ADDENDUM NO. 001

Architects Project No.: 23042

Project Name: Ralston Apartment Renovations

UNIT PLANS

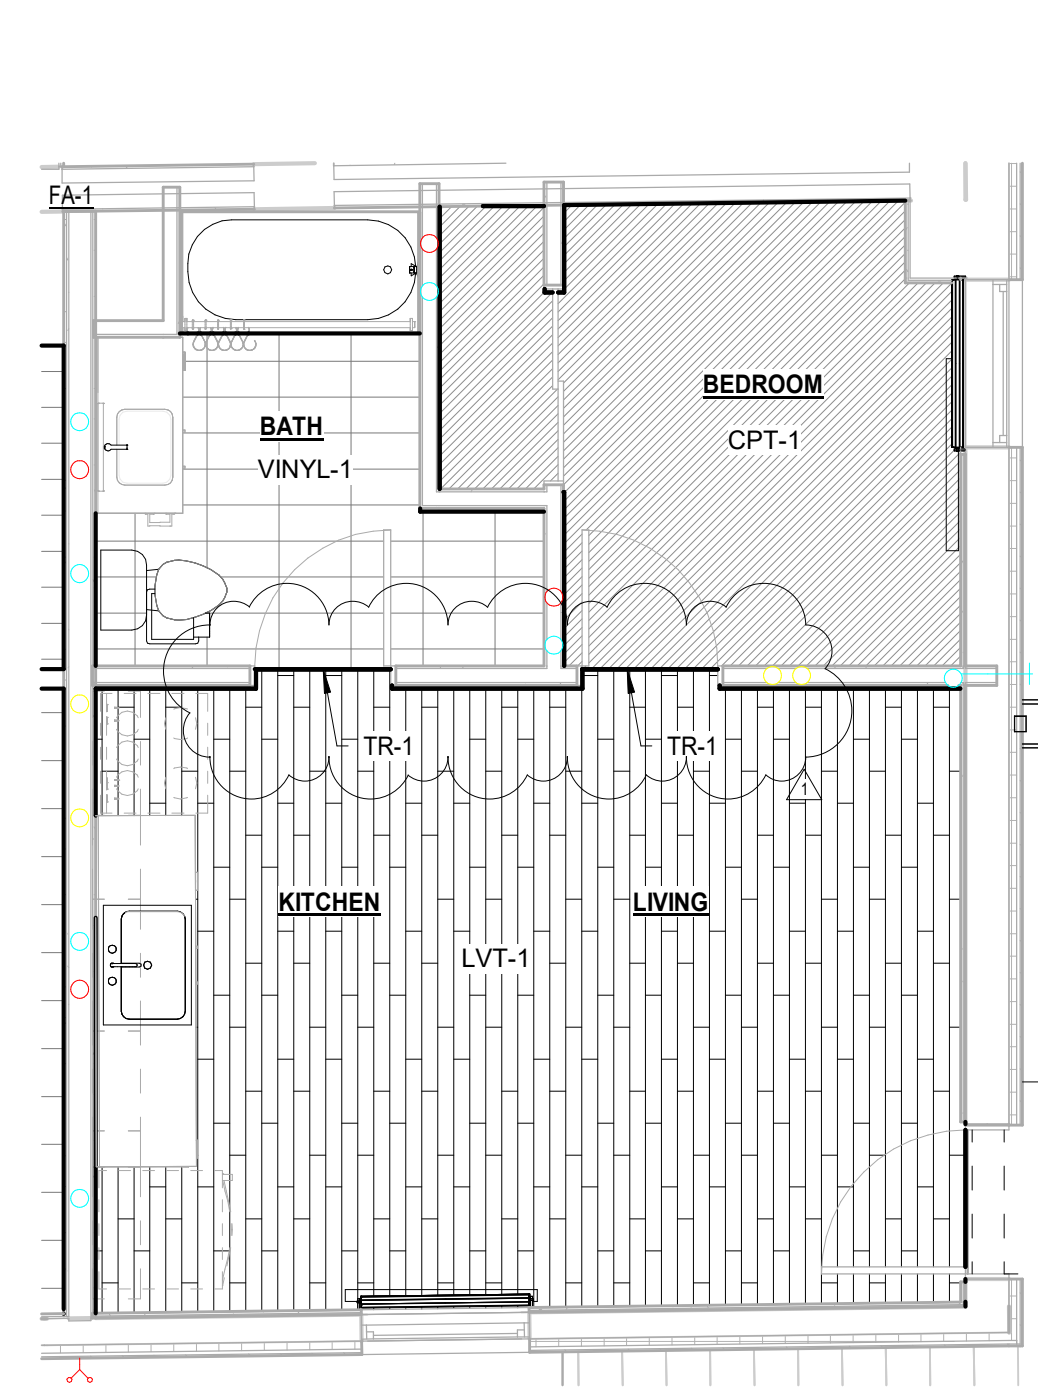
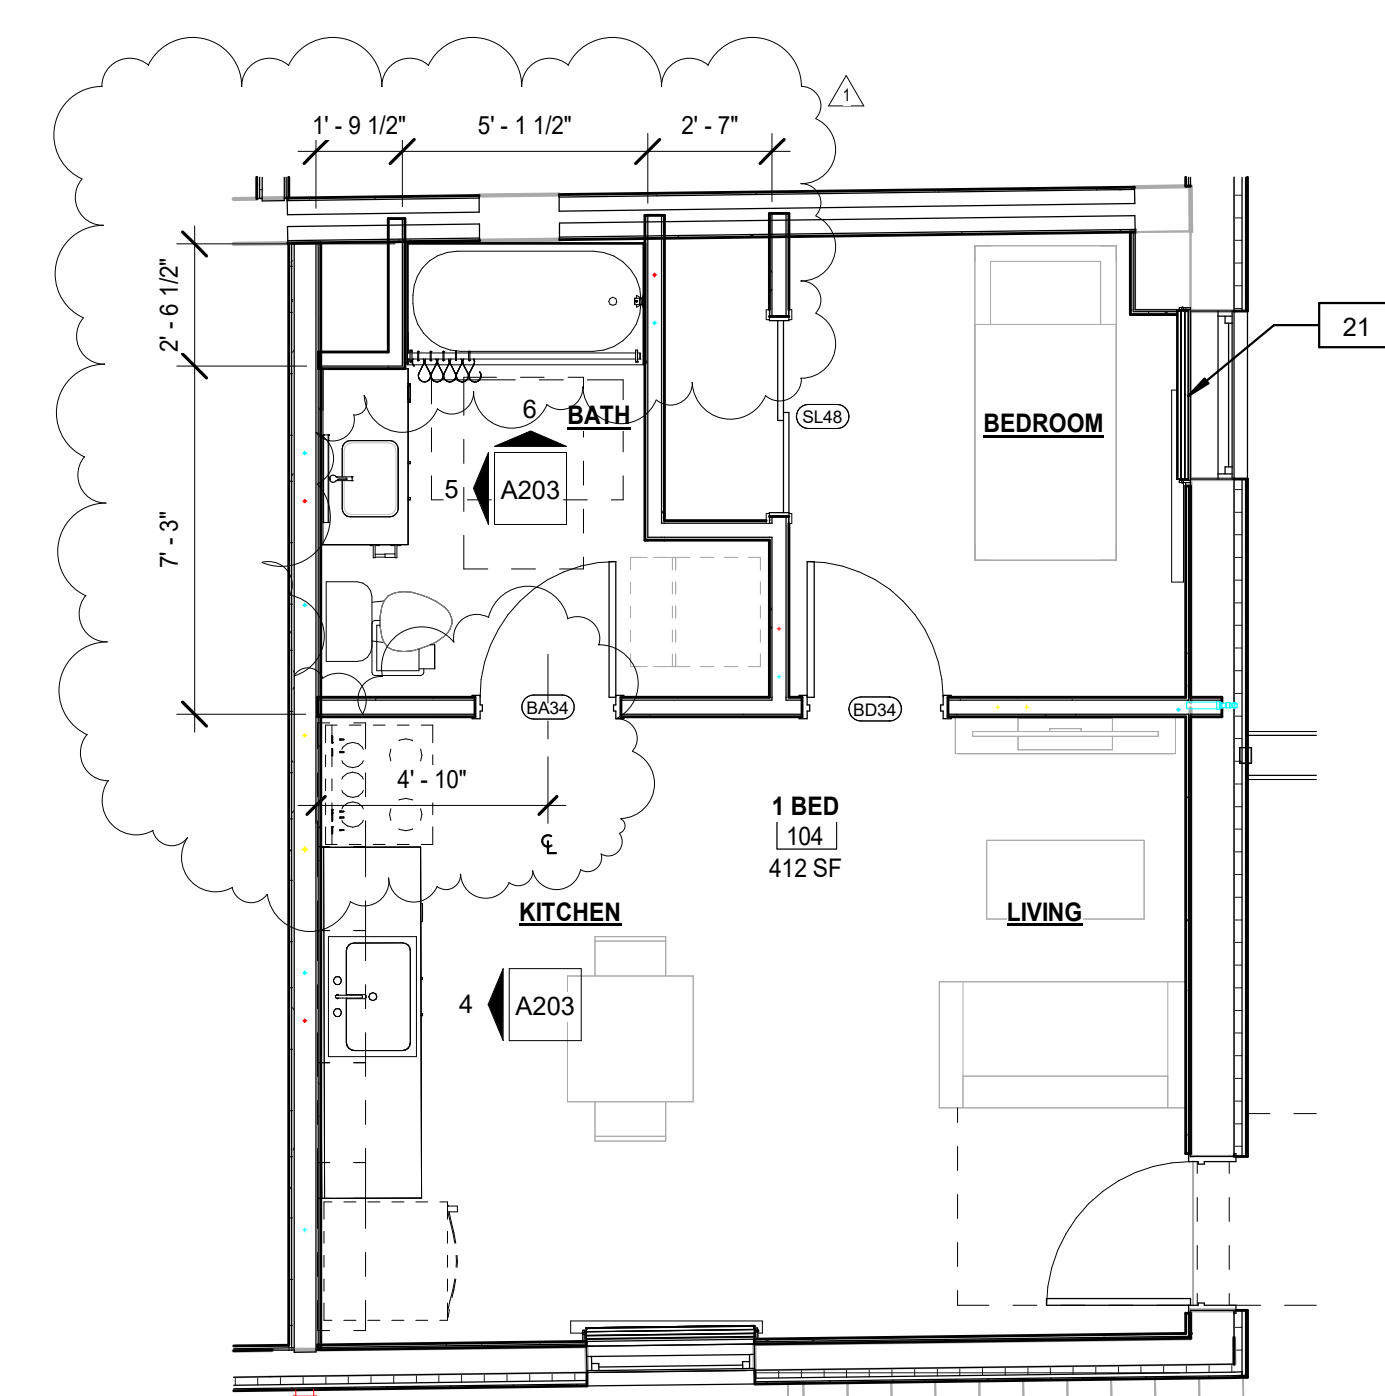
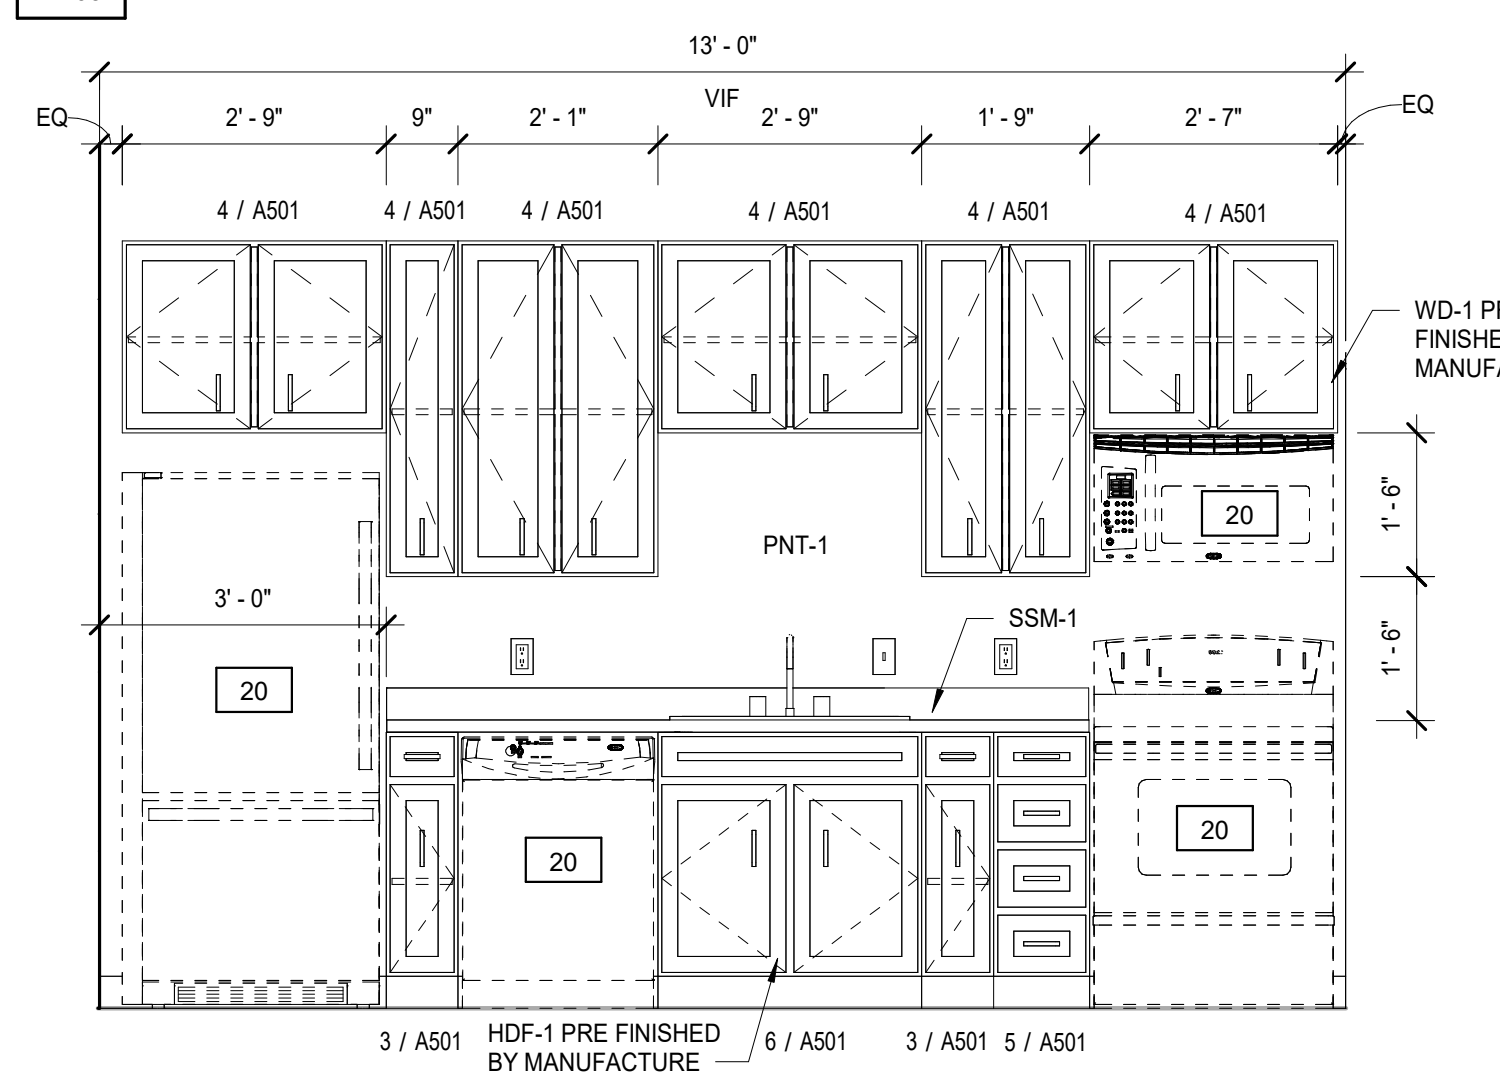
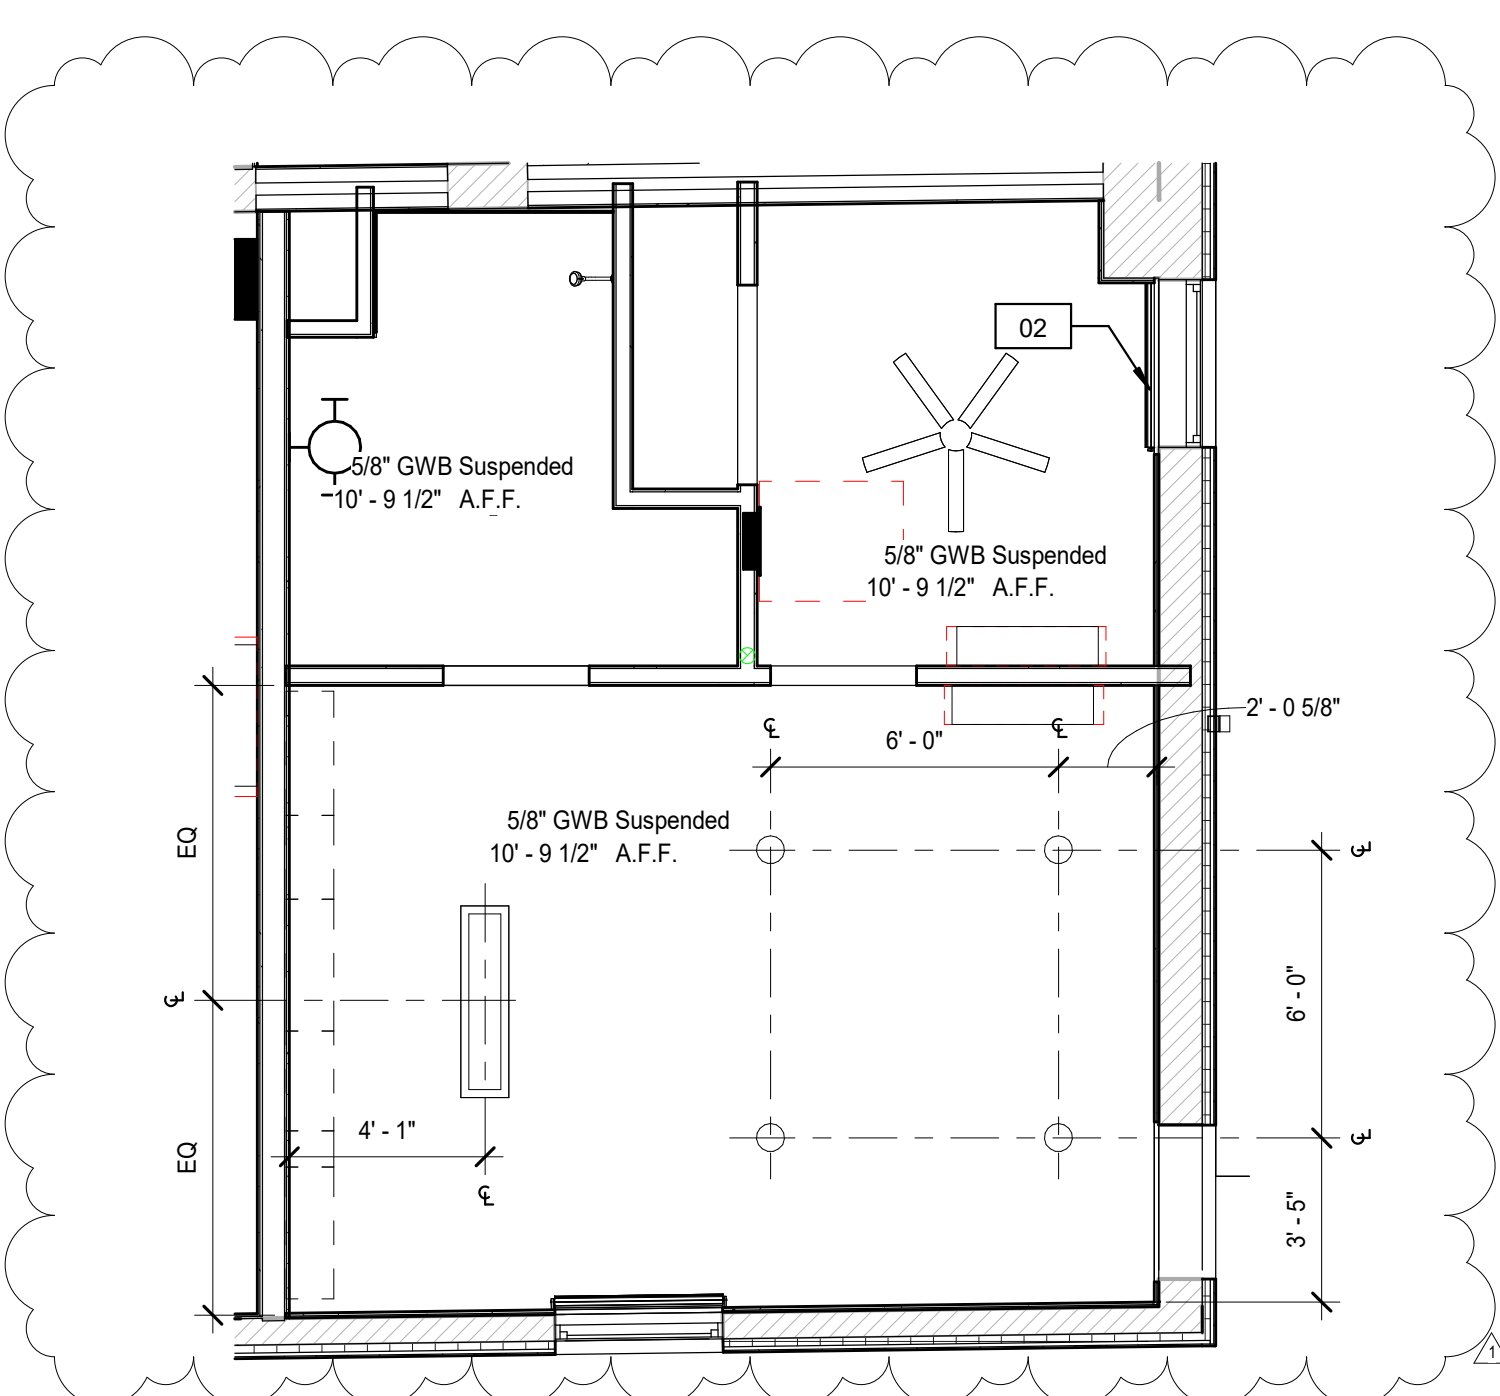
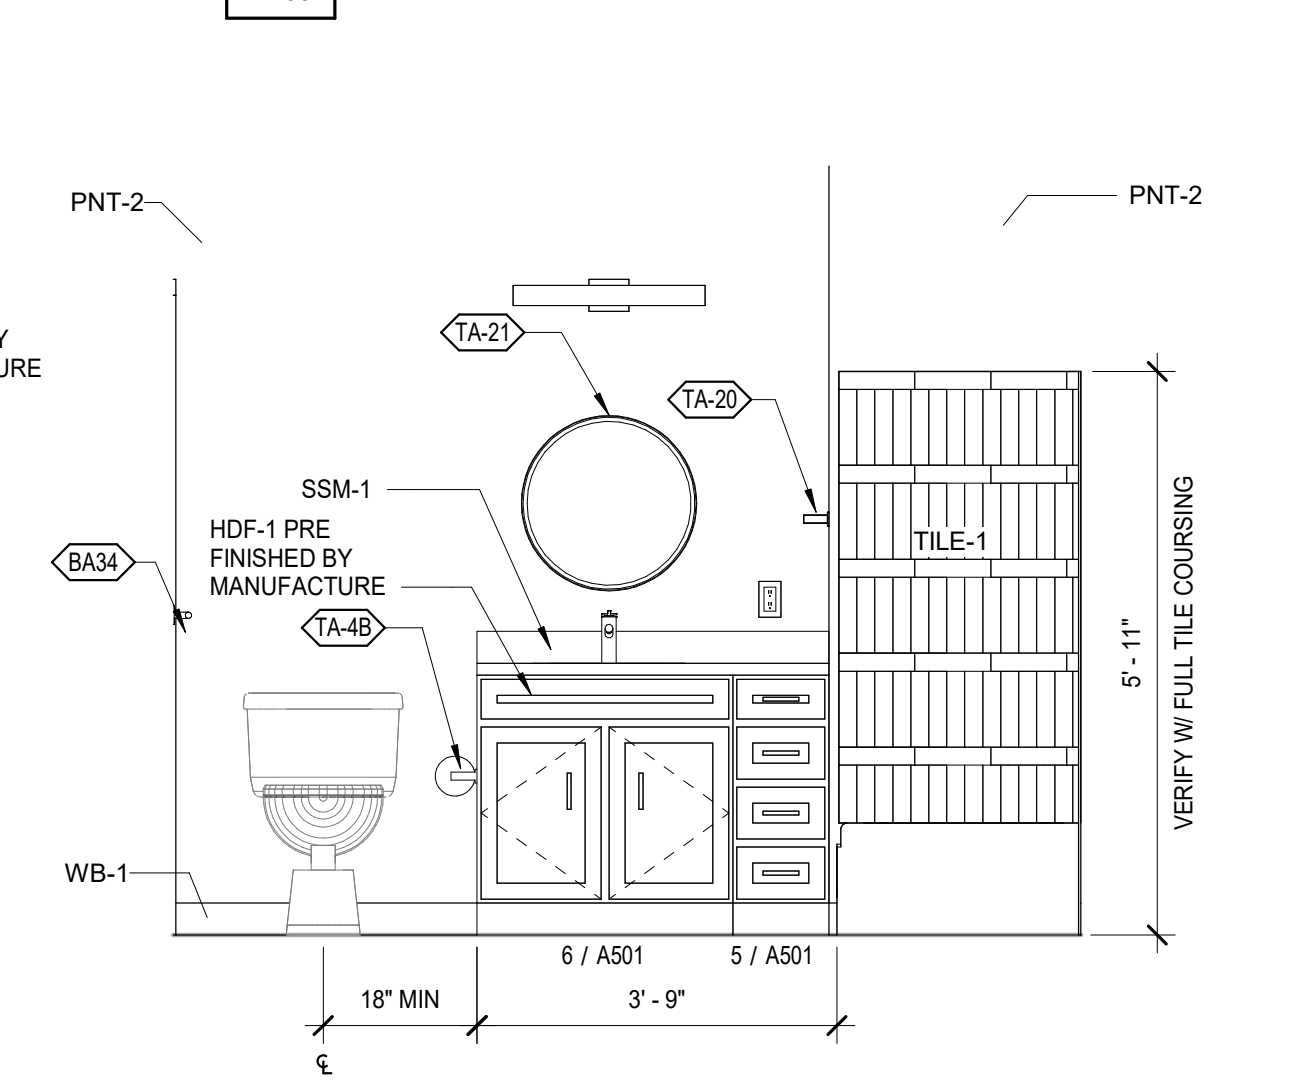
- a. 1/2" Counters
7. Is there a door hardware schedule available?
 - a. See added sheet A801 for hardware sets
8. The material list on sheet A203 shows Vinyl-1 should be located at the bathroom and kitchen floors, but the finish plan shows LVT-1 at the kitchen floors. Also, the material list shows Vinyl-1 as a vinyl tile, but it is a rolled vinyl product. Just want to make sure this is what you are looking for.

- a. Added dimensions to ceiling lights
 - b. Clarified dimensions on detail 3, general drawing cleanup.
 - c. Graphically showing TR-1 on the finish plan.

- d. Updated solid surface material information.
 - e. Vinyl updated description to match product data and clarified install locations. Added transition strip TR-1.

- a. Vinyl tile should just be in Bathrooms. See Addendum 01 for clarification on the color schedule.
9. What type of plumbing pipe are we to use on the project? PVC, cast iron, galvanized etc. Didn't see anything noted on the plans.
